Woodrow Wilson Bridge Project

Implementation of Noise Abatement Recommendations

William Bowlby, Ph.D., P.E.
Bowlby & Associates, Inc.

June 25, 2007
City of Alexandria

Route 1, East Side along Patrick Street

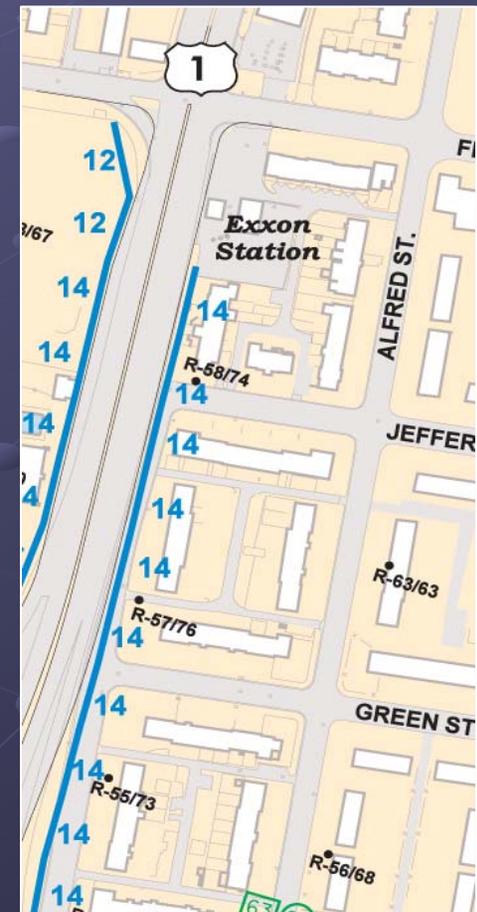
- **Recommendation:** *Increase height of barrier along Patrick Street by 2 to 6 feet, resulting in total height of 14 feet above U.S. 1 pavement.*
- **✓ VDOT action:** Done.
- **Recommendation:** *At north end, consider extending barrier eastward 30 feet off state right-of-way along property line between Exxon station and townhouses.*
- **✓ VDOT action:** Not done. Many issues, relatively small benefit.

**Temporary wooden noise barrier along south edge of Church Street
by exit ramp**

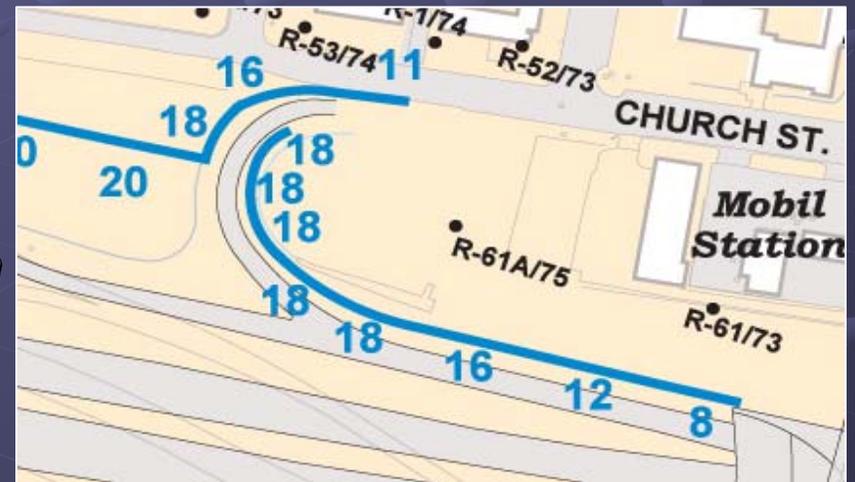
- **Recommendation:**
Extend barrier on west side of ramp farther north and east along edge of ramp to help minimize noise coming through gap to homes along Church Street.
- ✓ VDOT action: Done. Eastern end is taller in height and shorter in length than shown to accommodate construction needs.

South Side, Hunting Terrace

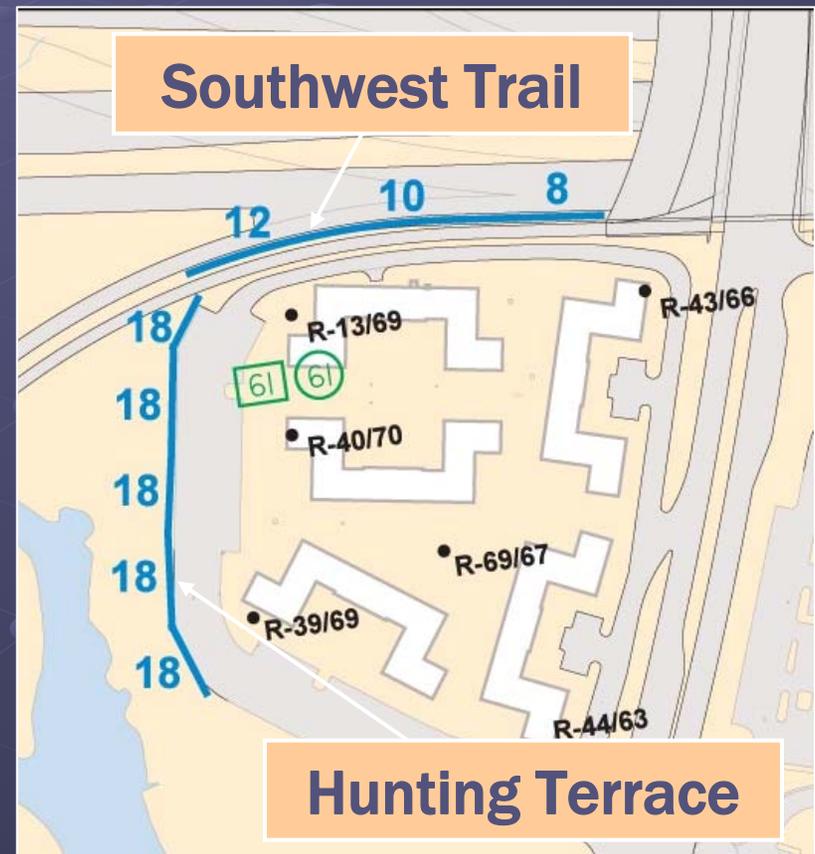
- **Recommendation:** Consider reducing length of overlap of the two barriers.
- **✓ VDOT action:** Done. Western end taller than recommended (not shown).
- **Recommendation:** Consider reducing height of barrier along parking lot from 20 feet to 18 feet; consider eliminating southern-most segment.
- **✓ VDOT action:** Left height and length as designed (not shown).

Southeast Trail (Hunting Towers)

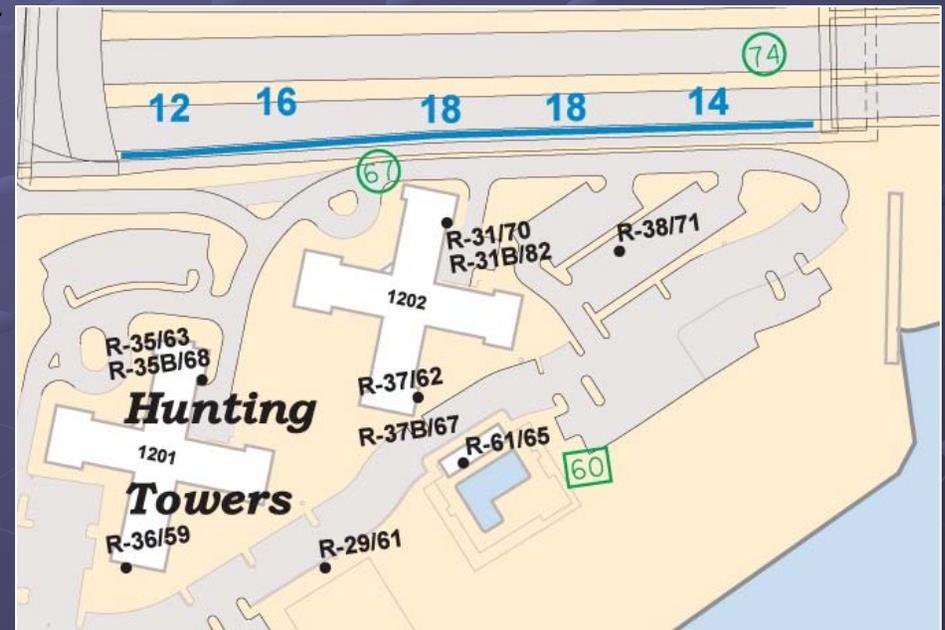
- **Recommendation:** *Consider sound insulation for apartments that will still have interior noise impacts, such as windows, balcony doors, balcony enclosures.*
- **✓ VDOT action:** Not done. Not allowed in VDOT noise policy. Ineligible for Federal funding.
- **✓ VDOT action:** Made center parts of barrier taller than Bowlby recommended.
- **✓ VDOT action:** Made highway sides of retaining walls to be sound-absorbing (all four quadrants).

Northeast Trail

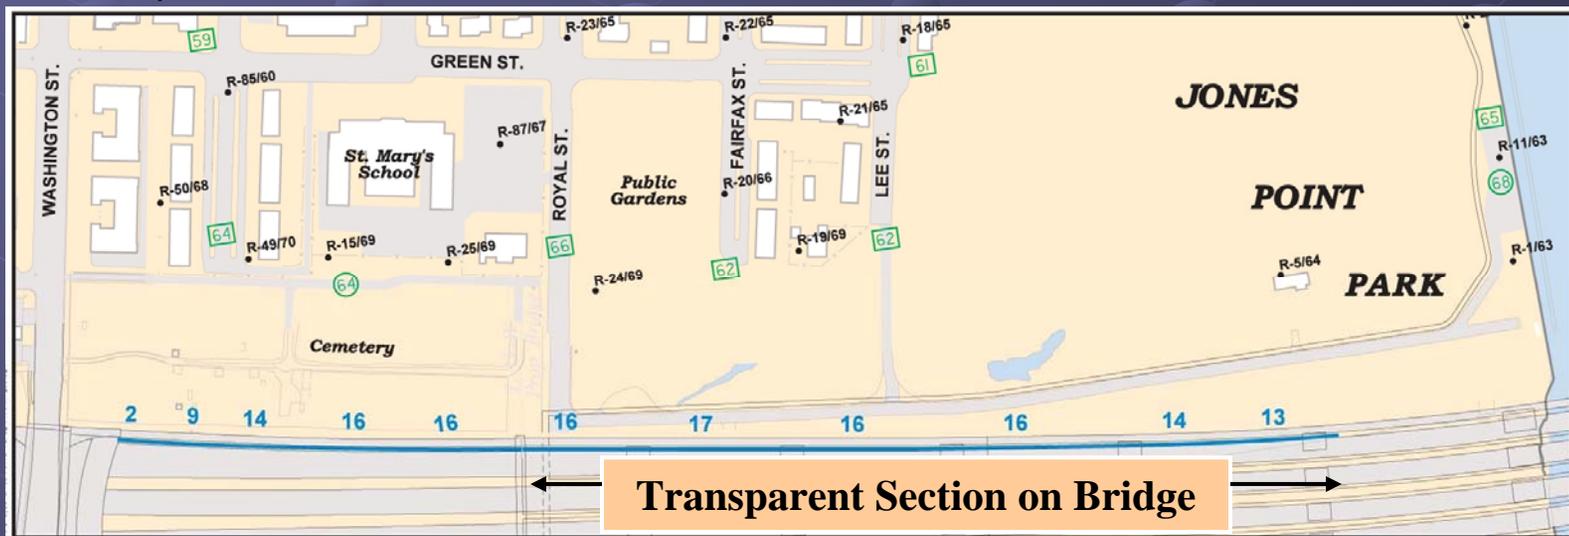
- **Recommendation:** *Extend planned noise barrier from proposed end at Royal Street eastward for approximately 1,300 feet on bridge, with height ranging from 14 feet near Royal Street to 8 feet at eastern end, using transparent, acrylic noise barrier material.*
- **✓ VDOT action:** Done, actually longer and taller (not shown).
